ENERGY NORTHWEST

Subject: **WNP-2, OPERATING LICENSE NPF-21
REQUEST FOR AMENDMENT
TECHNICAL SPECIFICATION 4.3.1.2.b
(ADDITIONAL INFORMATION)**

**REQUEST FOR AMENDMENT TECHNICAL SPECIFICATION 4.3.1.2.b
(ADDITIONAL INFORMATION)**

NEW FUEL VAULT - DIAGRAM 2

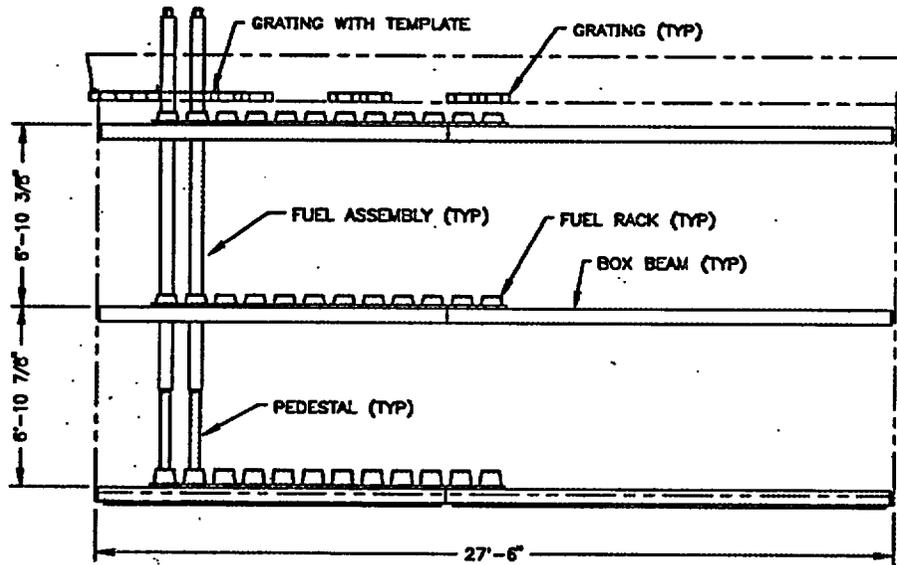
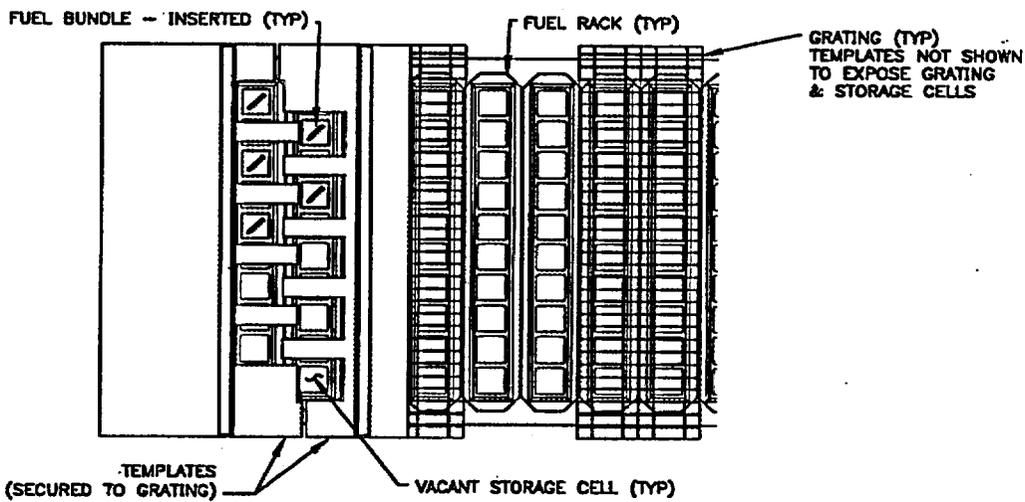
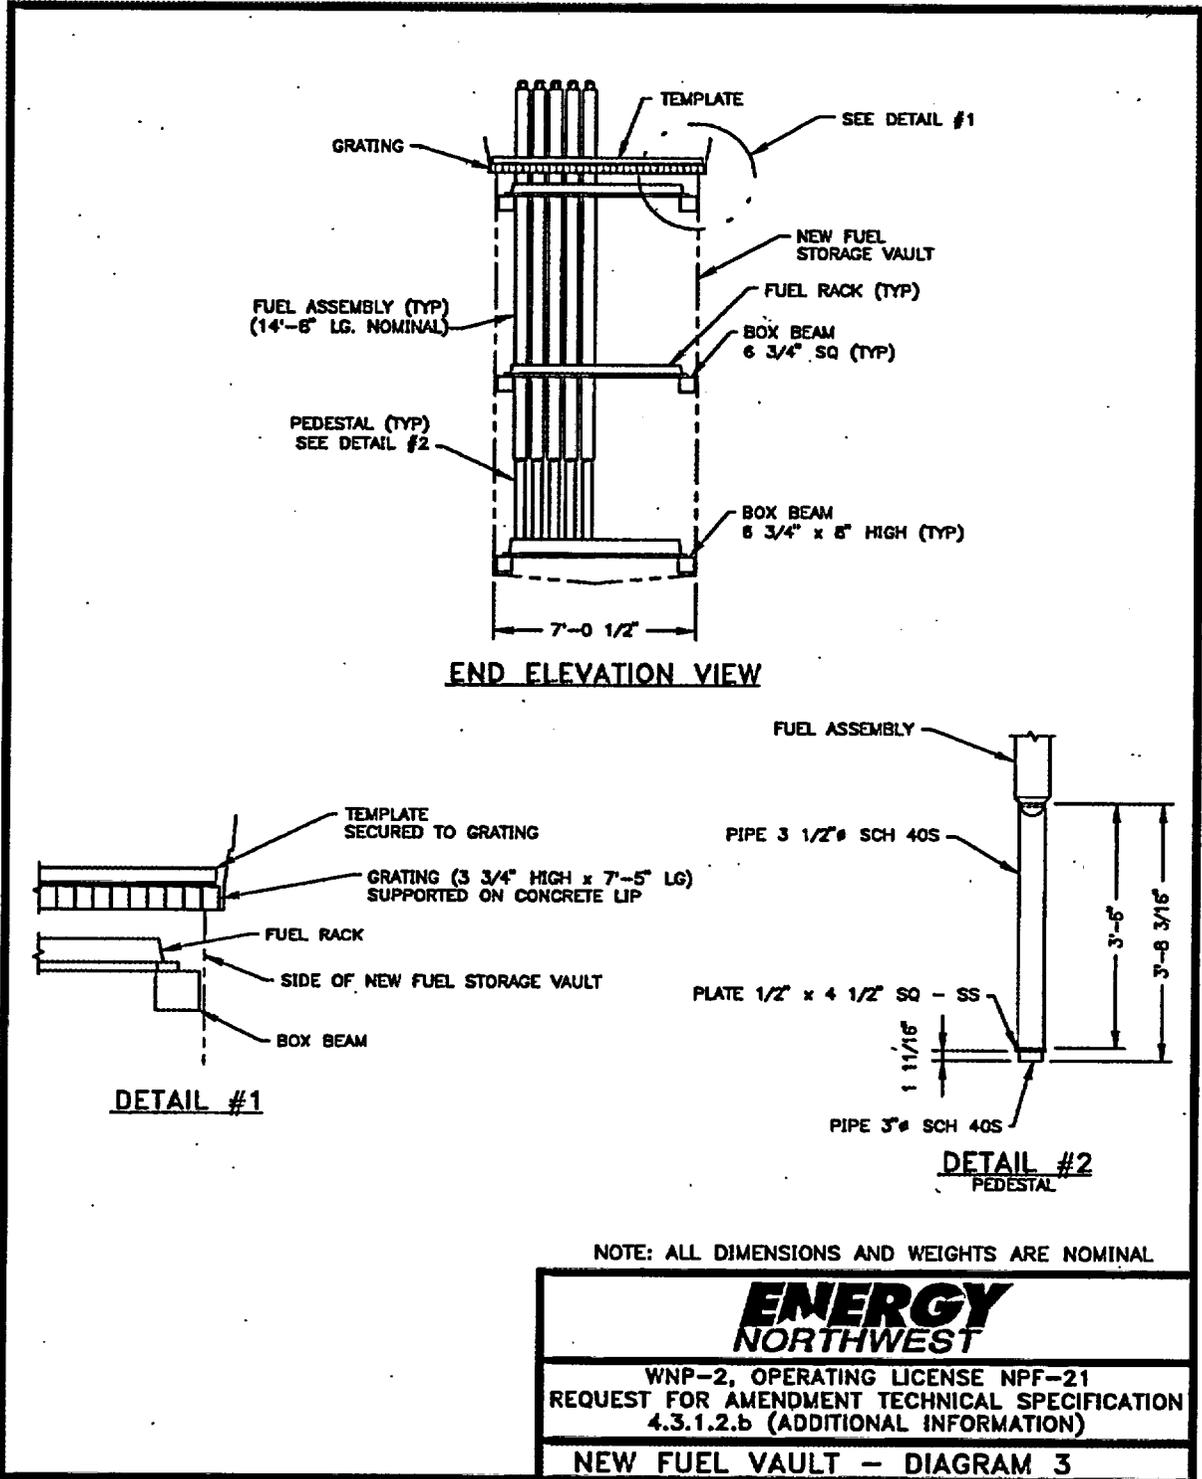
Discuss briefly the types of analyses (including any seismic dynamic analysis) performed to determine the structural integrity of the various elements affected by the new geometrical limitations for storage of new fuel assemblies in the new fuel racks. This discussion should include the analyses related to the accidental drop of the fuel assemblies being supported by the pedestal.

A structural analysis has been performed to verify the structural integrity of the new fuel racks resulting from the new geometrical limitations of the new fuel rack support system. See attached diagrams of new fuel storage rack arrangement. The configuration control components used in the new fuel vault consist of a series of templates and working platform grating sections and a fuel support assembly (pedestal).

The templates and working platform grating sections allow only $\frac{1}{4}$ of the total design capacity of fuel assemblies to be installed (60 vs. 240 assemblies). The templates permit every other location in two fuel rack rows to be available for fuel assembly storage in a checkerboard pattern and then skips two rows in between where the working platform grating resides. The working platform grating prevents any fuel from being inserted. This pattern is repeated, as necessary, for the volume of fuel assemblies to be stored up to the limit of 60 fuel assemblies. Each template is fabricated from $\frac{1}{4}$ inch aluminum plate and is a non-structural element that adds no weight to the fuel rack beams or their supports. The template is securely mounted on and fastened to the working platform grating. The working platform is supported from the new fuel vault cover lip, independent from the fuel rack beams or their vault wall support box beams. Thus, neither the templates nor the working platforms provide any loading to the fuel rack or its support system.

The other component is a "fuel support assembly" or "pedestal" which is placed on the lower fuel rack and acts as a spacer to raise the fuel assemblies approximately 42 inches for ease of inspection, exchange of the shipping handle with the in-vessel bale handle, etc. The pedestal is constructed of $3\frac{1}{2}$ inch stainless steel schedule 40 pipe. The strength characteristics of the pedestal are sufficient to support the fuel assembly in the receptor cell in the lower fuel rack beam. This pedestal securely fits into the lower fuel rack beam in a structurally similar manner as a fuel assembly and accepts the new fuel assembly into its tube section in a structurally similar manner as did the lower fuel rack. The pedestal employs a 3 inch stainless steel schedule 40 pipe section to achieve a slip fit design and a square plate to assure proper centering and fit into the fuel rack receptor cell. The pedestal is less than 5% of the weight of a fuel assembly.
